Technical Memorandum:

Review of MW Proposed DSS for Casey Fields South (Employment) and Devon Meadows PSPs – Supplementary Submission 1

Date: 28/05/2025
Project Number: 2101096, 2102129, 2300328
Project Name: Casey Fields South (Employment) & Devon Meadows PSP drainage strategy consultation
Authors: [REDACTED]
Reviewer: [REDACTED]
Version: 1

Scenario 3 - BW Concept

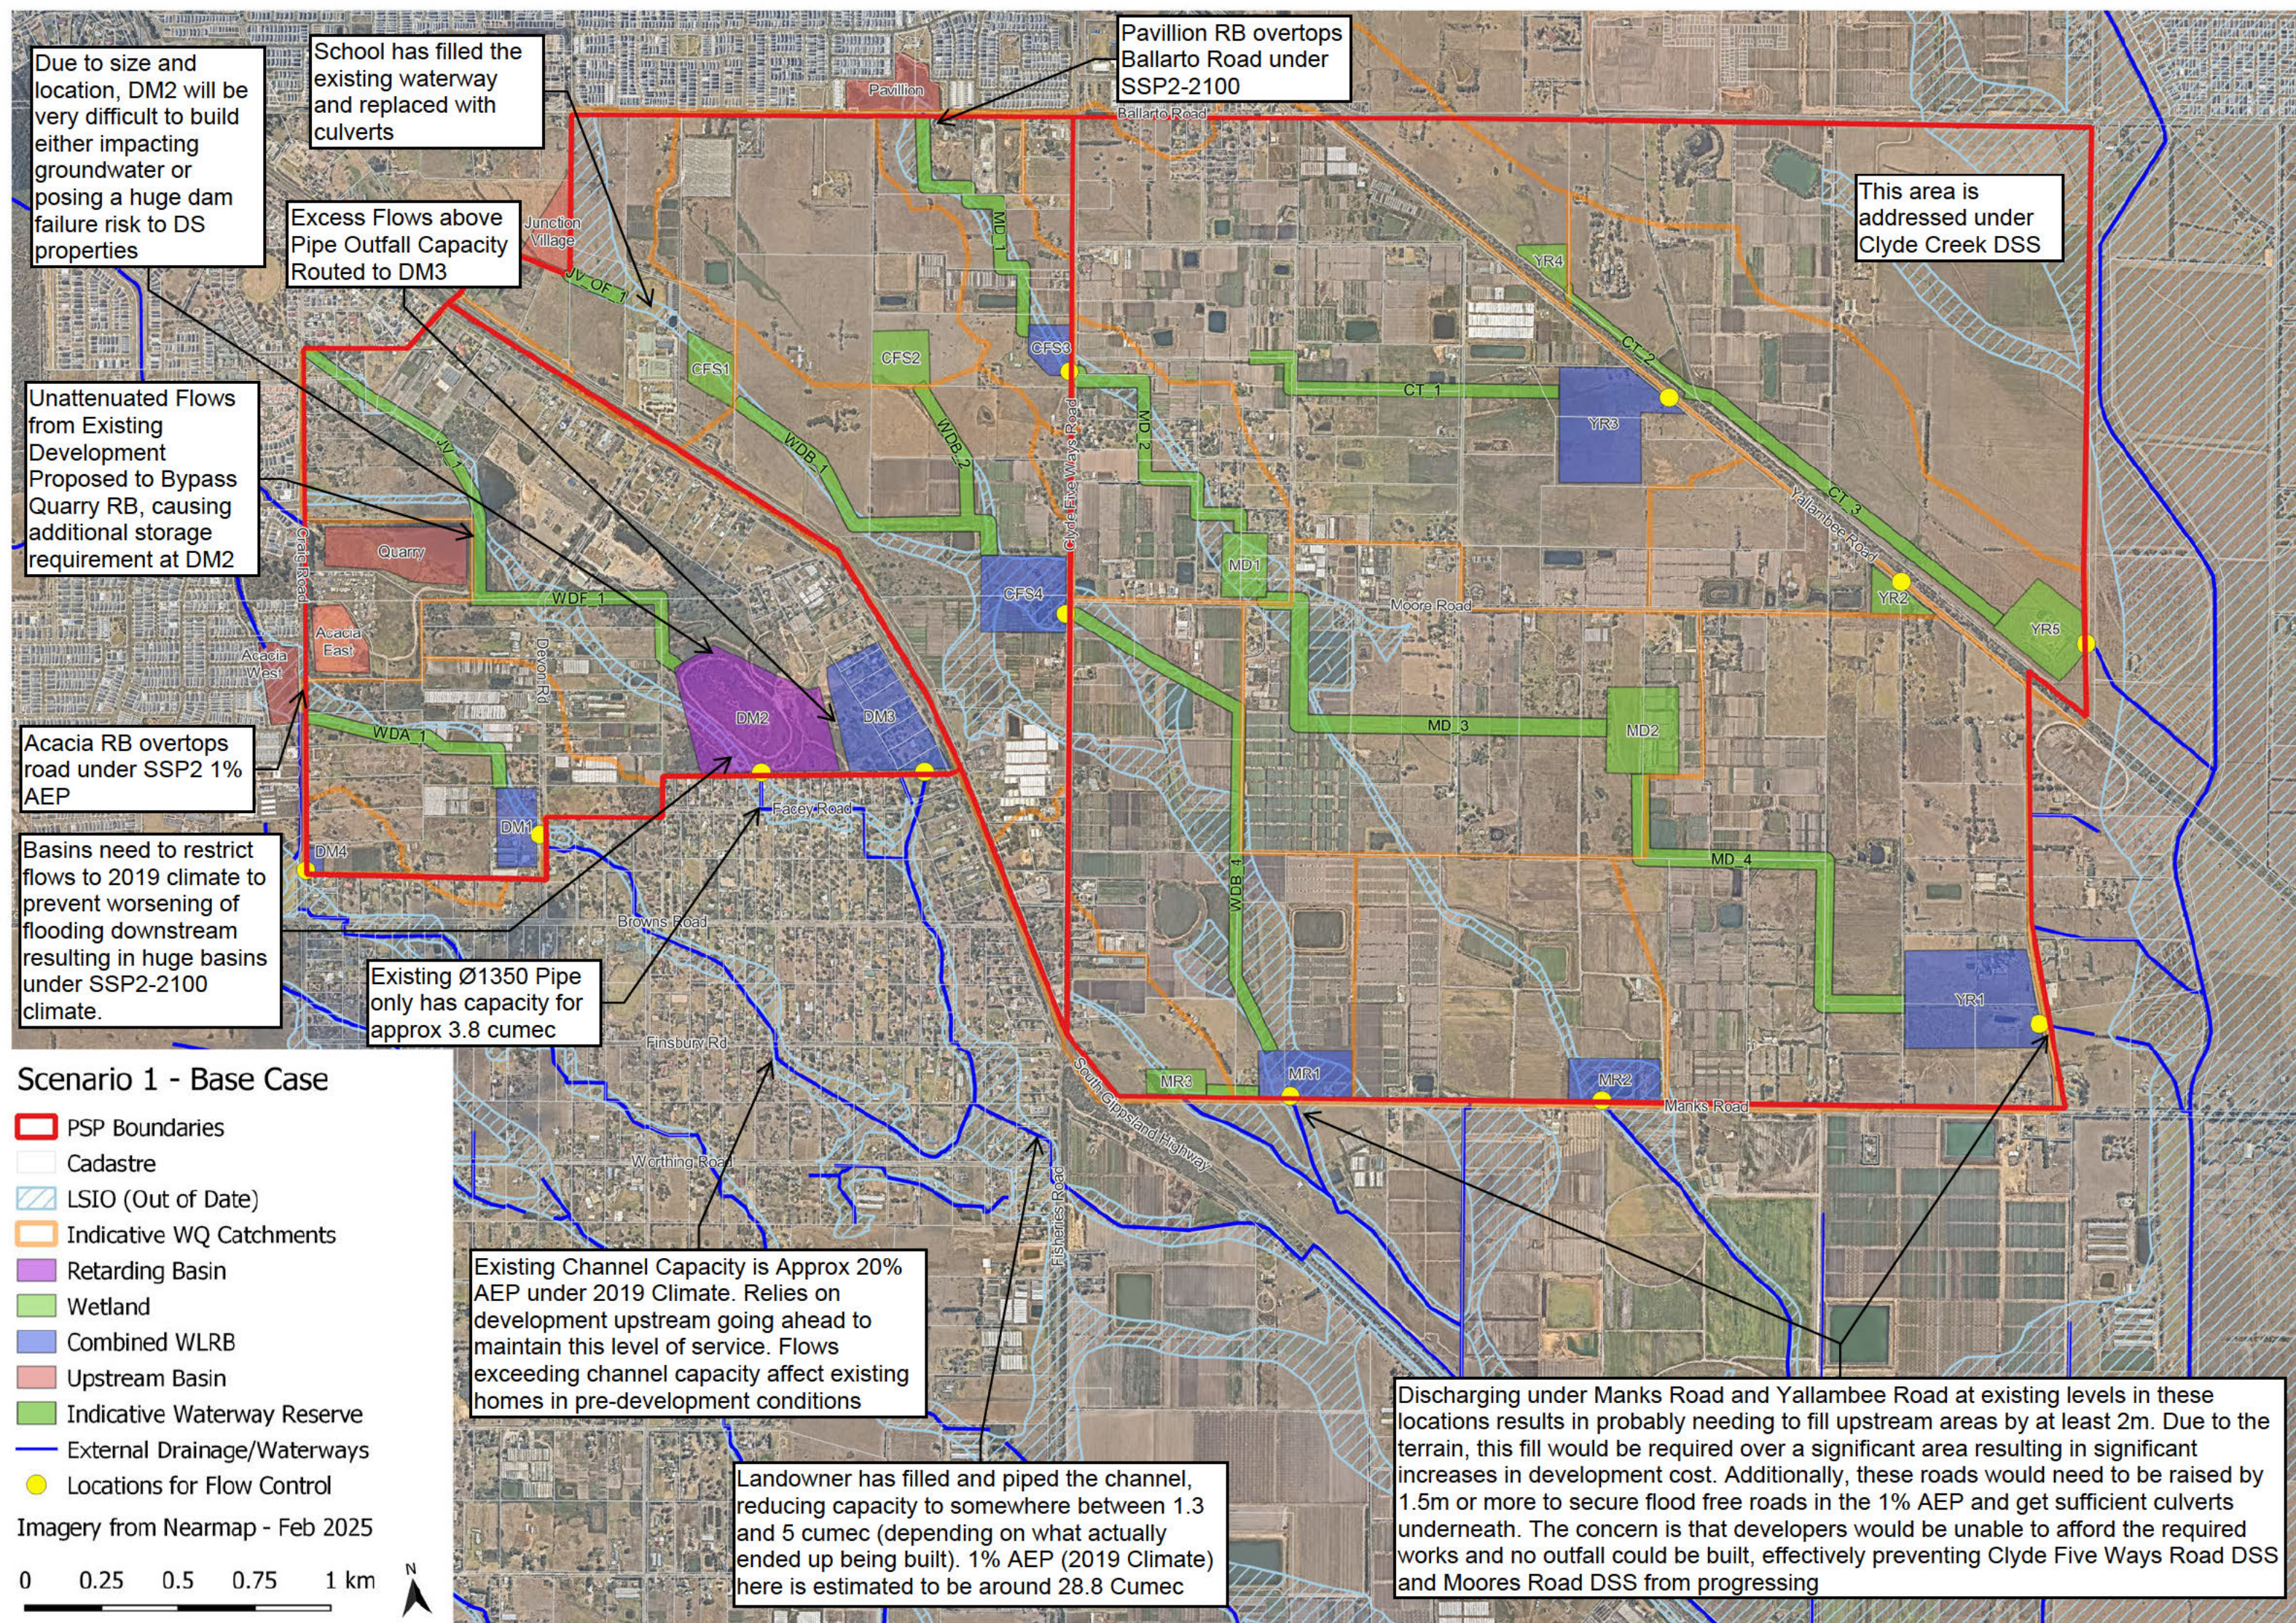
Waterway needs to be upgraded to convey additional flows, probably to 60m wide and also deeper as well, potentially increasing fill across the precinct

The diversion allows DM2 and DM3 to be significantly reduced

While channel redirection improves the expected flow rates in existing Devon Meadows, due to timing and climate change, peak flow discharging via Wylies Drain Main Branch under SSP-2100 1% AEP is still expected to reach 18 cumec, meaning these properties will still be flood affected in the major event

Basin volume blows out by approximately 450,000 cu.m to accommodate additional flood volume from the Devon Meadows catchment. Note that the Devon Meadows catchments are approximately 2.5 times bigger than what naturally drains here, so this volume all needs to be stored so that peak flows can be discharged to downstream at pre-dev flow rates. The increase in land take would probably exceed reductions in Devon Meadows upstream

Issues with Yallambee Road unaddressed in this proposal meaning some of Casey Fields Precinct cannot be progressed

Provide an additional outfall and overflow weir from Acacia East to WDA_1 to prevent overtopping of Craig Road in SSP2-2100 1% AEP

Networks to rejoin DS of school at start of Waterway

Upgrade RB outfall and provide additional 500mm fill (min) on south side to adjust to meet SSP2-2100

Consolidate water assets into 1 large reserve (wetlands can be split in reserve area to prevent size being too large). Leverage lower channel to maximise storage reducing impact to downstream Clyde South

New 45m wide waterway diversion connecting Wylies Drain Branch B to the Moore Road Drain via shortest alignment. Alternative alignments and locations of CFS4 are possible, but would probably increase cost and land take

Deeper channel allows additional flows to be accommodated without increase in reserve width. Would also reduce fill requirements to adjacent development

Lower basin YR1 allows additional flows from Casey Fields to be absorbed, while also reducing top basin level by around 1.2m significantly reducing cost of development in this area

Post development catchment
redirected to Moore Rd
Catchment to minimise flows
draining to Manks Road

Acquire 600m waterway connection to the Western Contour Drain/Clyde Creek. This would allow the entire Moore Road Drainage network to be lowered by approx 1.5m

Reduced catchment area means that peak discharge requirement can be met without a RB, lowering levels significantly and meaning less raising of Manks Road is required, and less fill/development cost

Upgrade existing waterways from ~6-8m wide to 12m wide and 1.5m deep (to convey approx 12.5 cumec) upstream of the confluence and 15m wide and 1.8m deep downstream of the confluence. This would convey the 1% AEP (SSP2-2011) with 300mm freeboard to top of channel providing improved flood protection to existing properties and protecting against climate change. We believe this could be done by only acquiring 2 properties on Fisheries Road and improving/upgrading access to a further 17 along the channel alignments
